# Access Compliance Report

## Public Rights-of-Way

| Intersection ID: 43145                  | Main Street: E_INDEPENDENCE_BV | Cross Street: E_INDEPENDENCE/BRIAR_CREEK_RA | Location: SW           |
| ADA ID: DDFC8887102D                    | Ramp Type: IslandPerp          | Initial Pass/Fail: Fail                     | Overall Compliance: No |

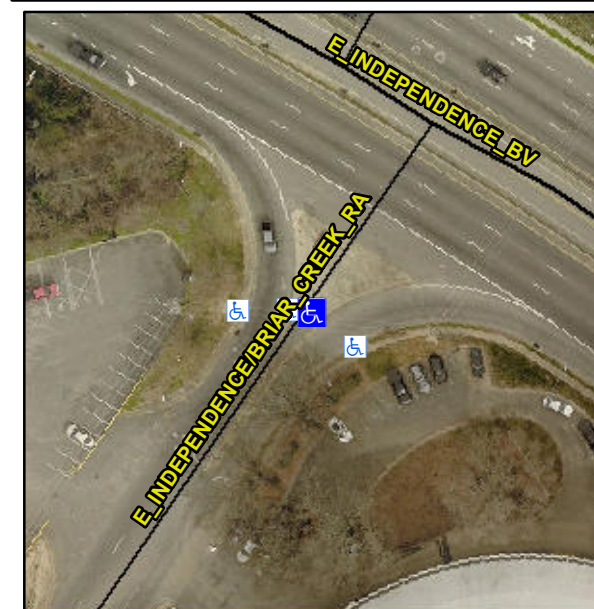
**Not Found, R304.5.1, R304.2.2, R304.5.3**

| Compliance | Description           | Data | Compliance | Description                 | Data |
|------------|-----------------------|------|------------|-----------------------------|------|
| N/A        | Ramp Length (in)      | 35.0 | No         | Ramp Slope (%)              | 12.1 |
| No         | Ramp Width (in)       | 44.0 | No         | Ramp XSlope (%)             | 2.5  |

**Remove & Replace Entire Ramp.**
